**Panel Report**

**Yarra Planning Scheme Amendment C191**

**Swan Street Activity Centre**

**15 October 2020**

**Figure 2 Comparison of perspectives from two different vantage point angles**

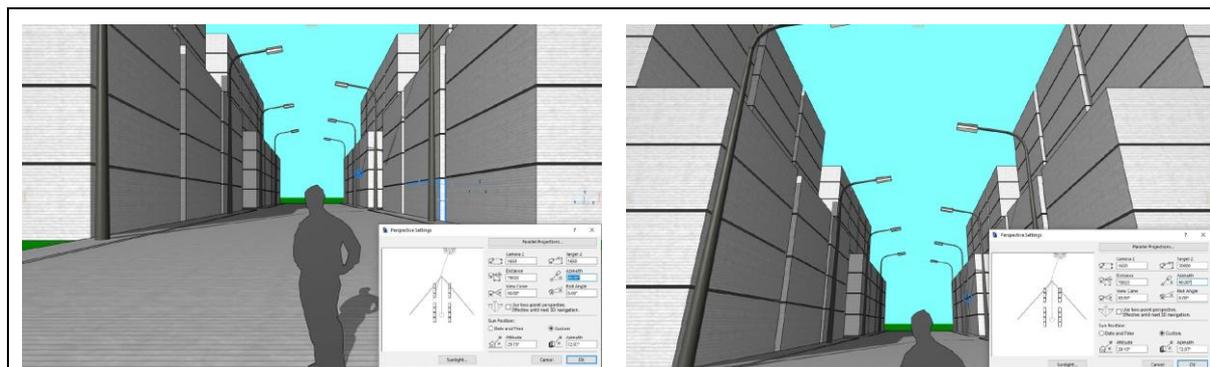
Swan Street Sales submitted that Ms Hodyl's work sought to illustrate, influence and persuade the Panel about the appropriateness of her recommended built form outcomes through inappropriate and distorted perspectives. It presented two different perspectives to illustrate distortion. These are replicated in Figure 2.

**Figure 7** Original Corner Hotel building in its c1869 form

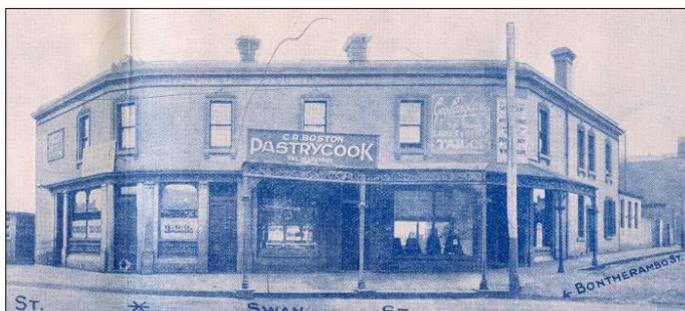
Mr Raworth included images of the original hotel building, as shown in Figure 7 and Figure 8 of this report, before it was demolished in 1955 to make way for the current building. He disputed claims in the Heritage Review and by Mr Gard’ner that the building was constructed in the mid-1960s.

Mr Raworth explained that the Corner Hotel was significantly altered in the 1990s before being further altered in 2016. Alterations over time include:

- an extensive refurbishment of the roof top beer garden
- painting over the face brickwork
- new first floor wall to the Botherambo Street elevation
- most ground floor window openings to Stewart and Wangaratta Streets being infilled
- some windows to the Botherambo Street elevation being enlarged
- changes to a section of the Swan Street elevation where the bottle shop once existed.

Figure 10 Precinct 1 exhibited and resolved building heights and street wall interfaces

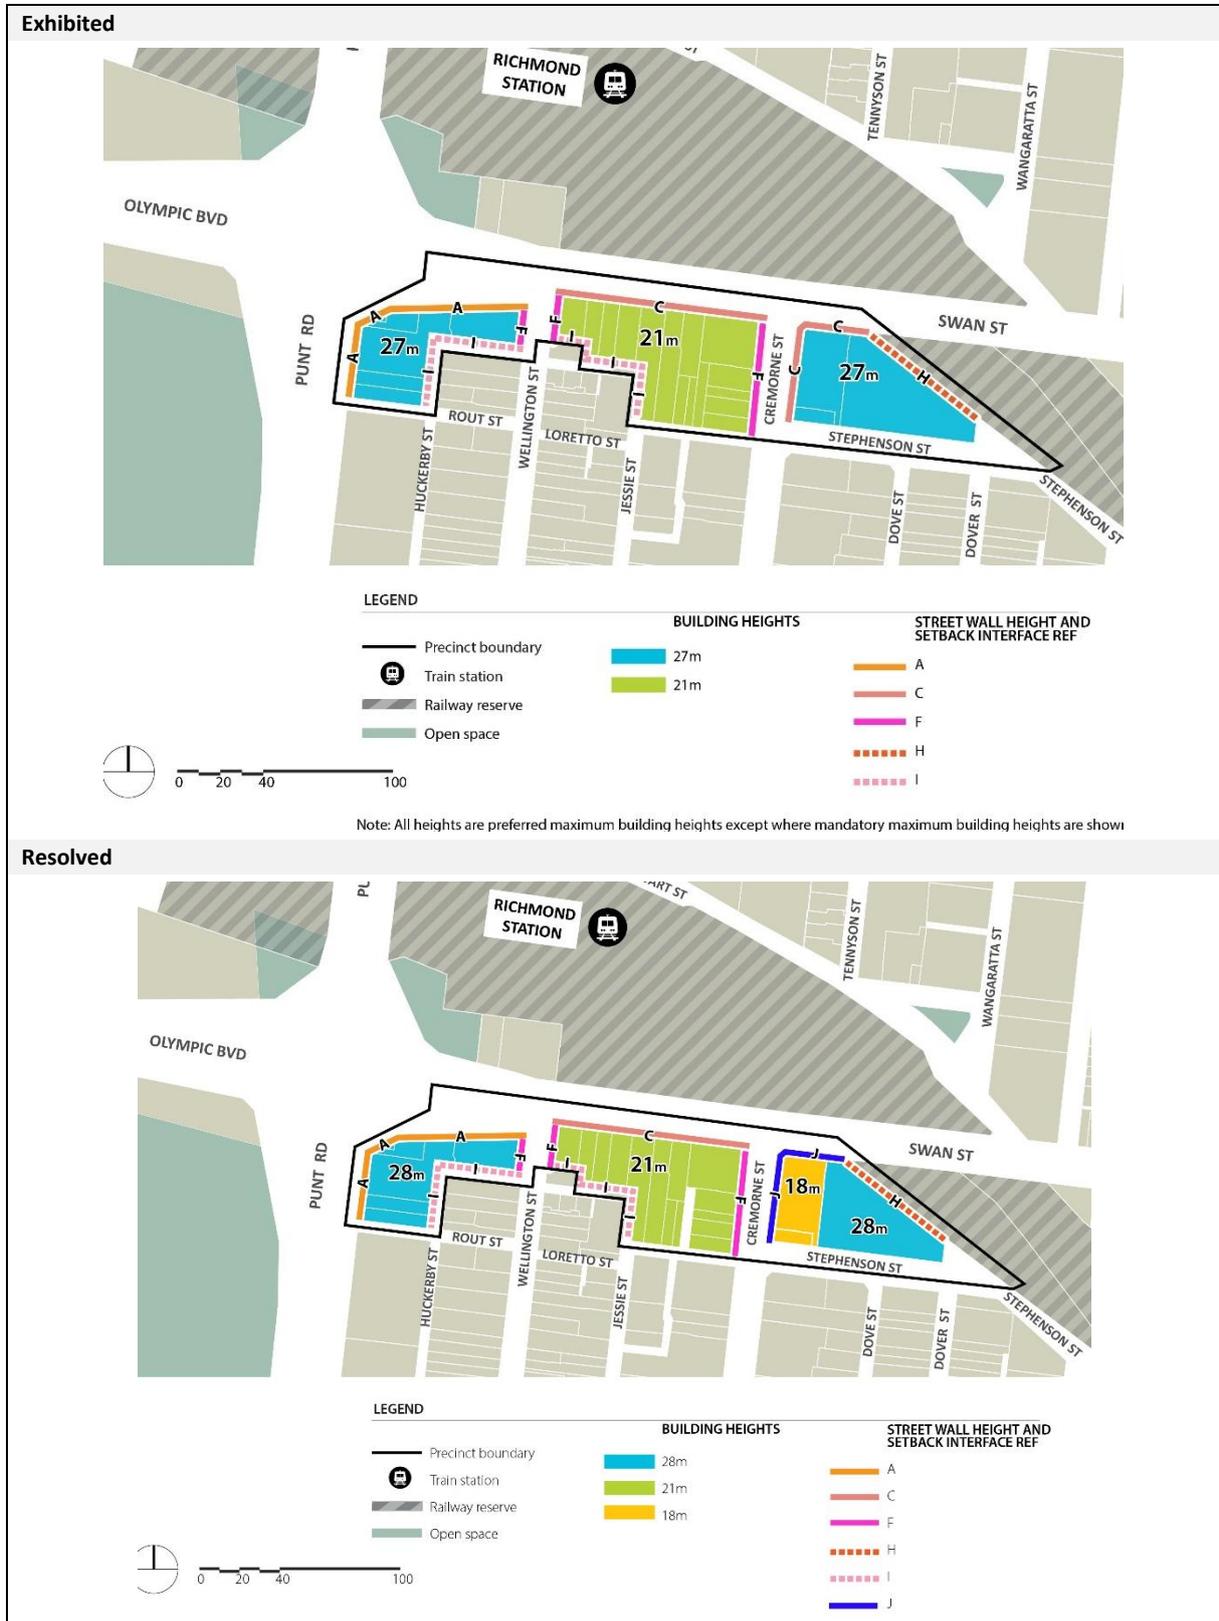
Height and interface plan and street wall heights and setbacks			
IR	Design Element	DDO17 exhibited requirements	DDO25 requirements
A	Street wall height	<b>Preferred:</b> 21m maximum	<b>Preferred:</b> 21m maximum
	Street wall setback	<b>Preferred:</b> 0m	<b>Preferred:</b> 0m
	Upper level setback	<b>Preferred:</b> 5m minimum	<b>Preferred:</b> 6m minimum
C	Street wall Height	<b>Preferred:</b> 11m maximum or the parapet height of the adjoining individually significant or contributory building if higher than 11m. 8m minimum. Match the parapet height of the taller adjoining heritage building.	<b>Preferred:</b> 11m maximum. 8m minimum. Match the parapet height of the taller adjoining heritage building, for a minimum length of 6m from the heritage building.
	Street wall setback	<b>Mandatory:</b> 0m	<b>Mandatory:</b> 0m
	Upper level setback	<b>Mandatory:</b> Minimum 5m for individually significant heritage buildings.	<b>Preferred:</b> Minimum 5m elsewhere. Any part of a building above the street wall must be designed to ensure that it occupies no more than one third of the vertical angle defined by the whole building in the view from a sight line of 1.7m (on the opposite side of the street).

Figure 11 Precinct 1 exhibited and resolved building heights and street wall interfaces

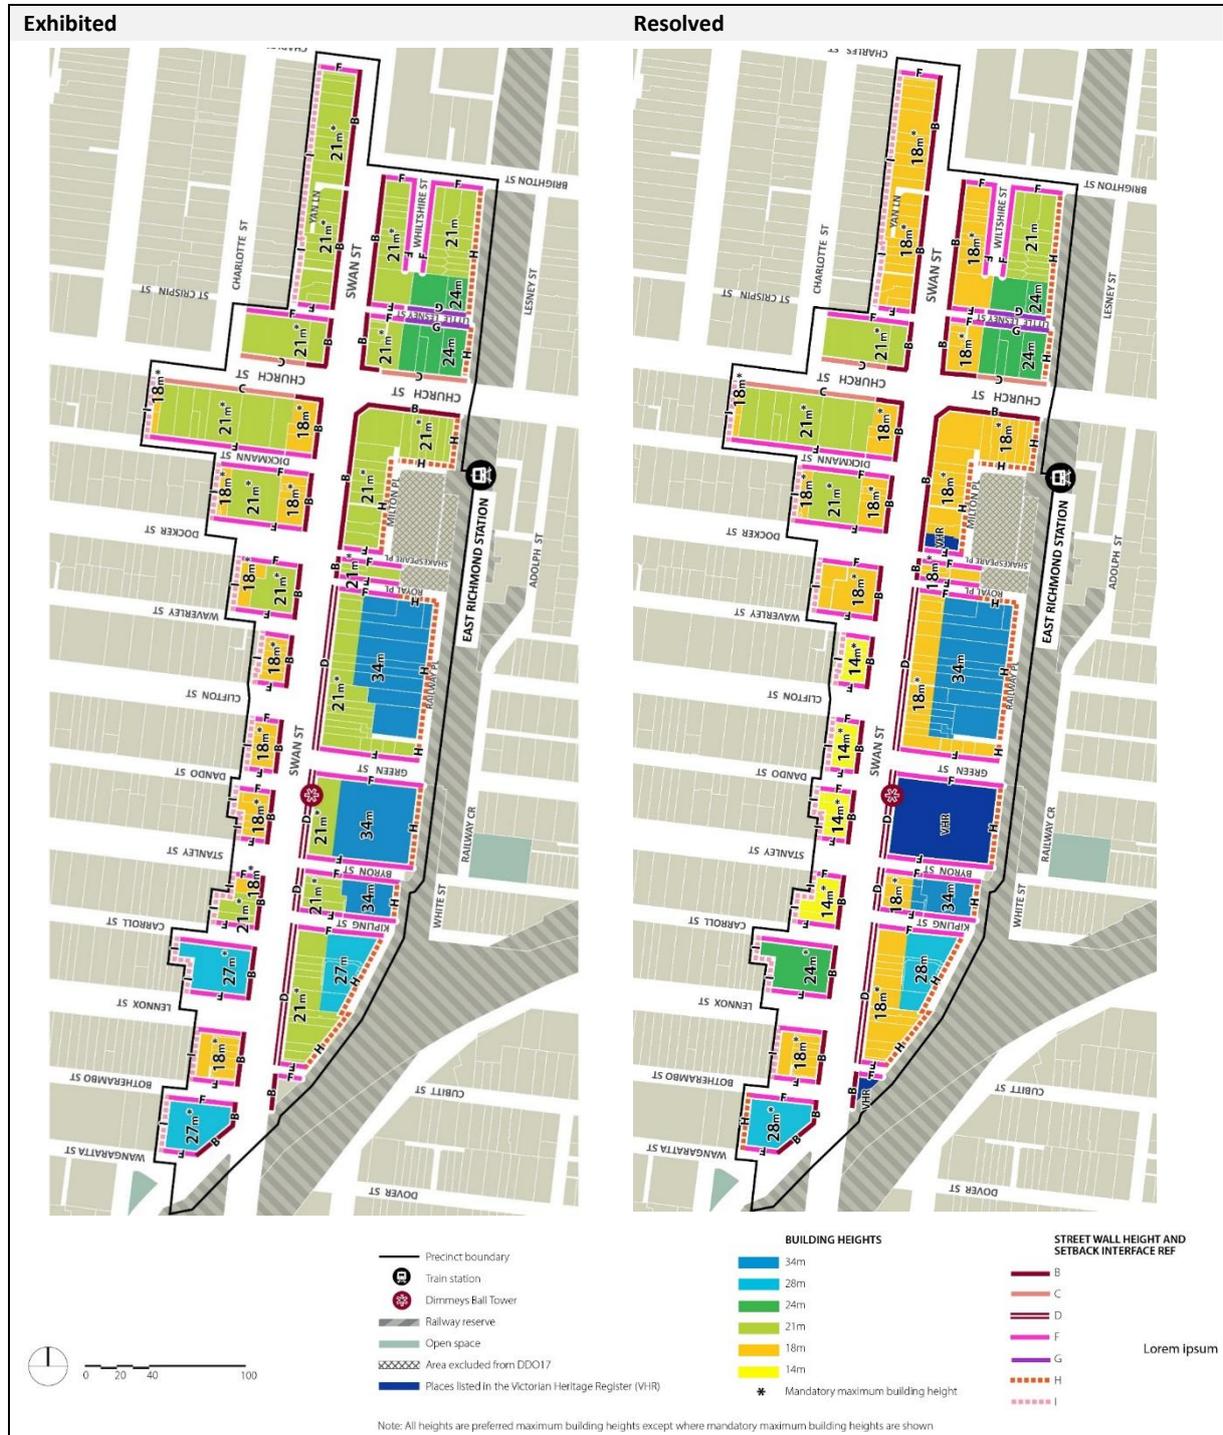
IR	Design Element	Exhibited DDO17 requirements	DDO26 requirements
B	Street wall height	<b>Mandatory:</b> 11m maximum or the parapet height of the adjoining individually significant or contributory building if higher than 11m.	<b>Mandatory:</b> 11m maximum. 8m minimum. <b>Preferred:</b> Match the parapet height of the adjoining heritage building, for a minimum length of 6m from the heritage building.
	Street wall setback	<b>Mandatory:</b> 0m.	<b>Mandatory:</b> 0m.
	Upper level setback	<b>Mandatory:</b> 5m minimum setback. <b>Preferred:</b> For all development in a heritage overlay, any part of the building above the heritage street wall should be designed to ensure that it occupies no more than one third of the vertical angle defined by the whole building in the view from a sight line of 1.7m (on the opposite side of the street).	<b>Mandatory:</b> 6m minimum setback.
C	Street wall Height	<b>Preferred:</b> 11m maximum or the parapet height of the adjoining individually significant or contributory building if higher than 11m. 8m minimum. Match the parapet height of the taller adjoining heritage building.	<b>Preferred:</b> 11m maximum. 8m minimum. Match the parapet height of the taller adjoining heritage building, for a minimum length of 6m from the heritage building.

- a) apply the building heights shown in the resolved version in Figure 11 of this report except for 57-61 and 187-189 Swan Street, land bounded by Little Lesney, Whiltshire and Brighton Streets, and 421-423 Church Street**
- b) apply a discretionary maximum building height of 28 metres to the part of 57-61 Swan Street currently being used as a car park**
- c) apply a discretionary maximum building height of 28 metres to land bounded by Little Lesney, Whiltshire and Brighton Streets**
- d) apply a mandatory maximum building height of 18 metres to 187-189 Swan Street and 421-423 Church Street.**
